Review of Existing Licence

Licence Number L6266/1991/10

Applicant Water Corporation of Western Australia

Premises Broome South sewage facility
34 Clementson Street
MINYIRR WA 6725
Lot 1639 on Plan 184761 and
Lot 512 on Plan 409418
As defined in Schedule 1 of the Revised Licence

Figure 1. Discharge of nutrients from a wastewater groundwater contamination plume to a tidal nearshore marine environment.

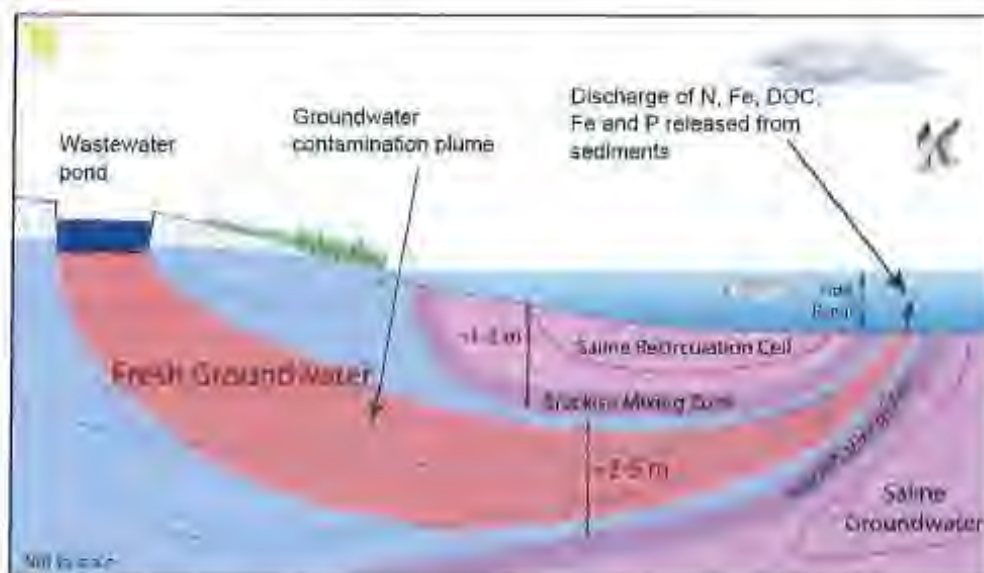
It is likely that both processes are taking place in Roebuck Bay, but there is insufficient information available to quantify each of these processes with any degree of confidence. In particular, *Lyngbya* blooms in Roebuck Bay commonly occur in still conditions after a heavy rainfall event suggesting that runoff is a significant source of the organic carbon that drives sediment hypoxia in the bay. Additionally, *Lyngbya* blooms often appear in shallow water near the Broome South sewage facility suggesting that the submarine groundwater discharge from leaking wastewater ponds may be a significant source of sediment hypoxia in this area (Fig. 1).

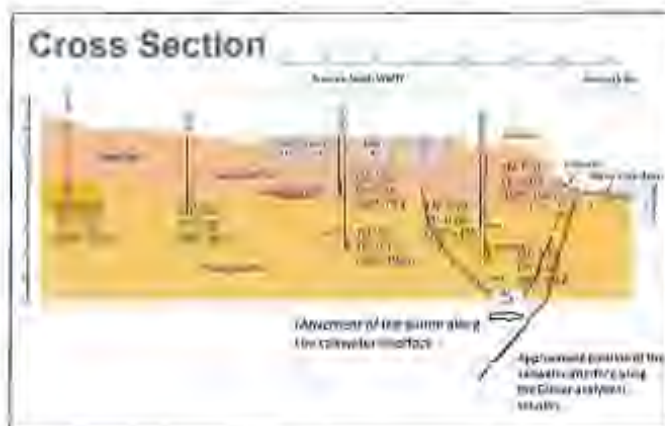
There are insufficient monitoring bores between the sewage facility and Roebuck Bay to determine whether there is a residual 'slug' of nitrogen contamination in groundwater that is discharging (or has the potential to discharge) nitrogen and other chemical constituents into the nearshore marine environment in the area (Fig. 2).

Calculations using the Glover analytical solution suggest that monitoring bores on the seaward side of the sewage facility have not intersected the saltwater-freshwater interface (refer to Figure 2), and therefore it is not possible to conclude that there is negligible groundwater discharge of contaminants to Roebuck Bay from the sewage facility based on the monitoring network that has been established at the site.
